Final Environmental Impact Statement
(Final Supplement to FEA FES 76/77-6)

**STRATEGIC PETROLEUM
RESERVE**

Bryan Mound Salt Dome
Brazoria County, Texas

United States
Department of Energy

Figure 2 CONCEPTUAL WATER INTAKE STRUCTURE
AT BRYAN MOUND

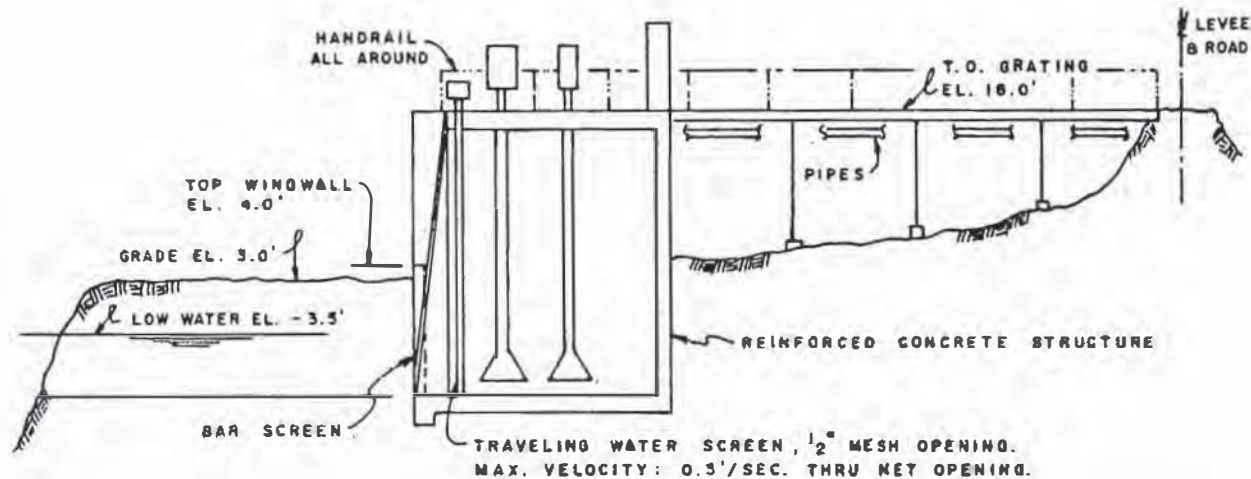
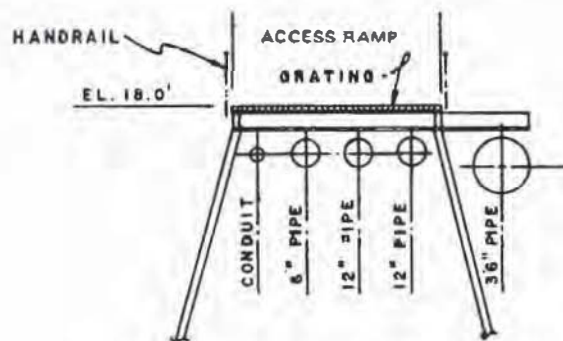
Pumps and mechanical gear susceptible to flood damage should be raised to an elevation at or above the one percent flood elevation in consonance with Executive Order 11988. "Normal flooding elevations" is an ambiguous term which does not specifically indicate compliance with the flood damage prevention requirements contained in the Executive Order. Figure 2 implies that susceptible gear is located above 18 feet elevation, but such items are not specifically labelled on the elevation view.

Figure 1 BRYAN MOUND REVISED FRESHWATER INTAKE AND BRINE DISPOSAL SYSTEMS LOCATIONS

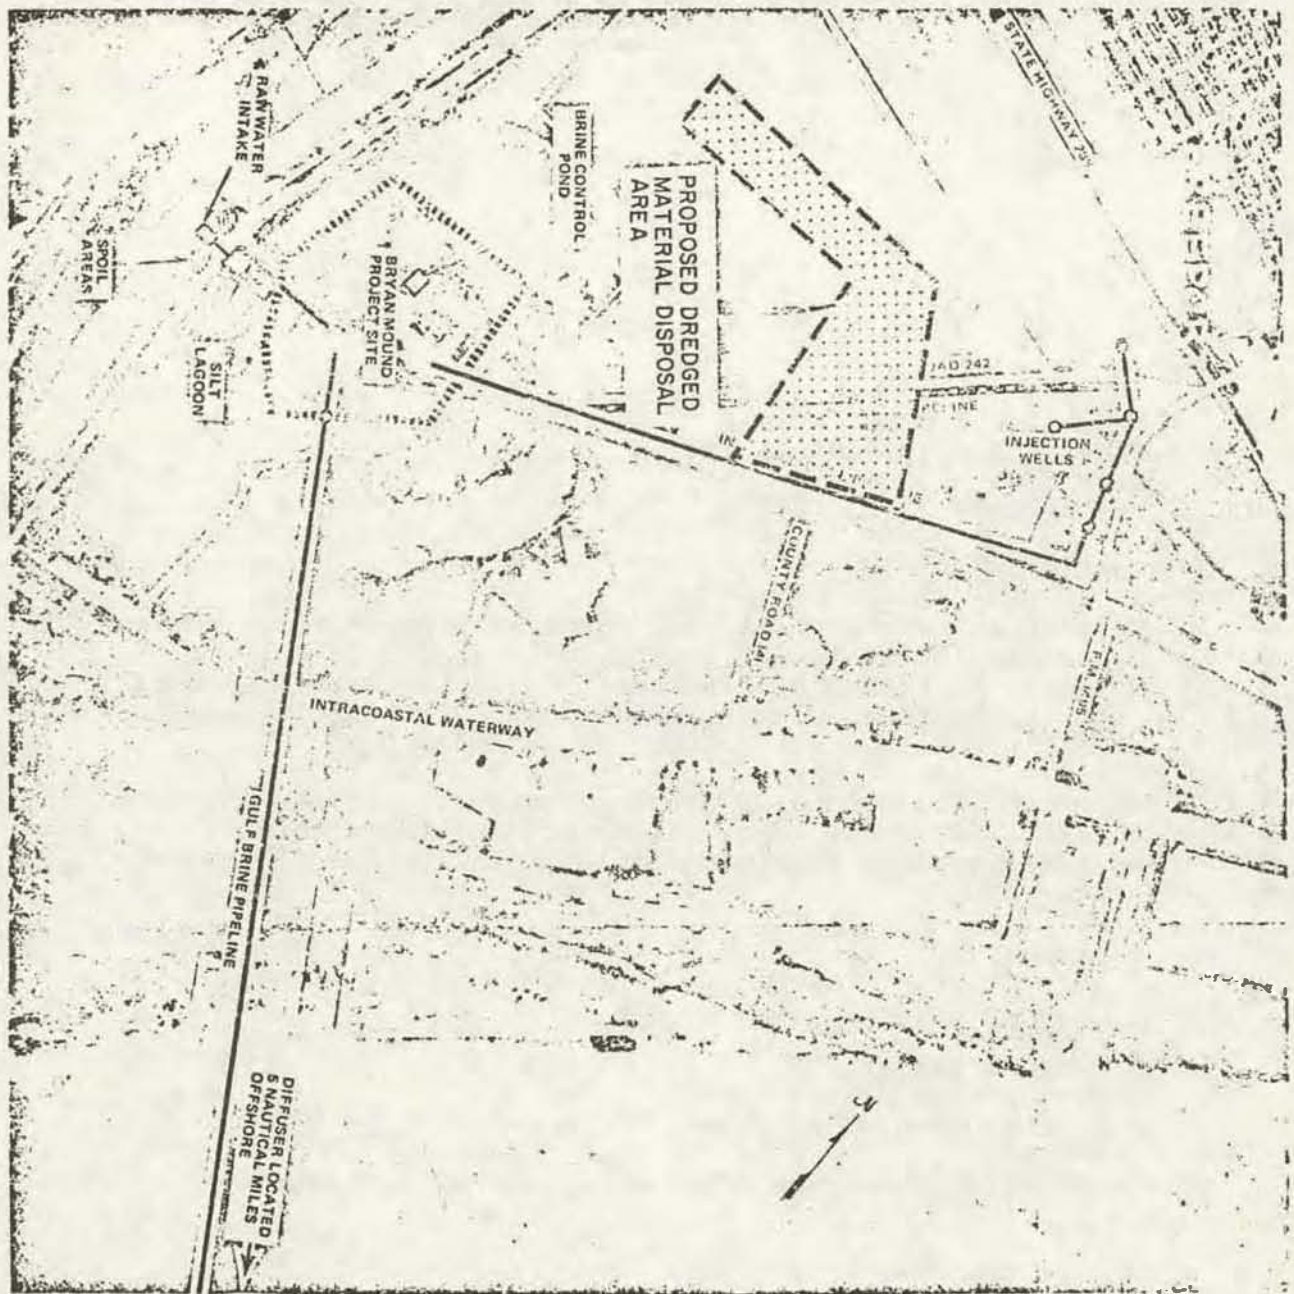
a. The authorized 45-foot Federal Navigation Channel Enlargement for Freeport Harbor would have a proposed dredged material disposal area near the injection well pipelines. A copy of Figure 1, page 4, showing the proposed dredged material disposal site is inclosed.

After consultation with the U.S. Fish and Wildlife Service, National Marine Fisheries Service, Texas Parks and Wildlife Department, and the U.S. Corps of Engineers the proposed well locations as denoted in the draft statement, figure 1, page 1-4, have been moved from west of route 1495 to the east side as illustrated in figure 1. This eastward relocation will place the well pads in an area which has a lower marsh habitat value and has been designated as a Corps of Engineers spoil disposal area for the Freeport Harbor project.
